**PRODUCT SUPPORT BULLETIN No.0199**

**PRODUCT:** TC-90 and TC-150 Compactors

**SUBJECT:** Lattice Mounting Changes

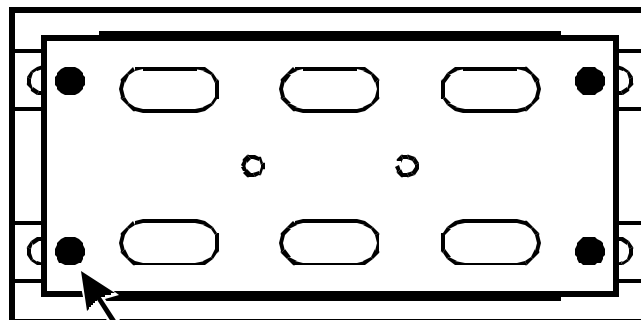
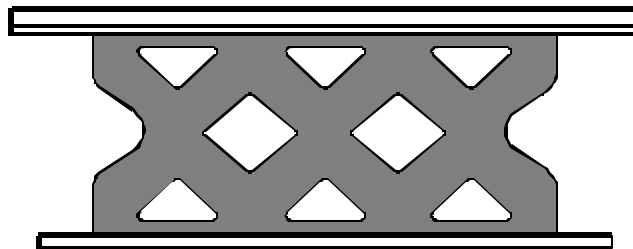
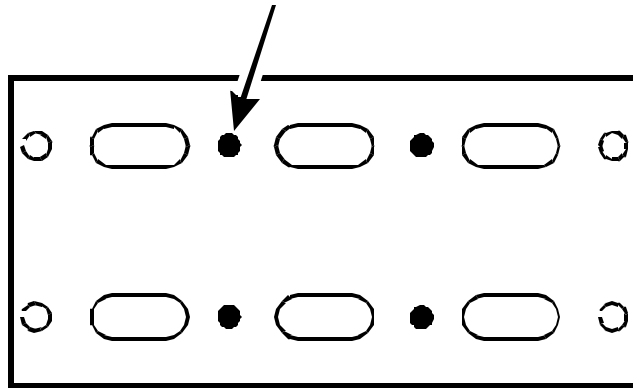
As a design improvement to the lattice mounting for the TC-90 and TC-150 the mounting holes have been increased to use a 3/4" bolt for better securing of the smaller plate.

This means the new lattice will not mount directly to the previous compactors (up to and including serial number 3833), unless they use thick washers with the existing 1/2" bolt. This prevents the washers deforming and the bolts loosening.

NOTE: The top plate of the lattice mount now has eight holes instead of four. This has no effect on previous installations.

These four holes do not exist  
on previous Lattice Mount designs  
(no effect on previous installations)

3/4" Bolts  
(previously 1/2" Bolts)

Teledyne recommends modifying the base plate to facilitate the larger bolt.
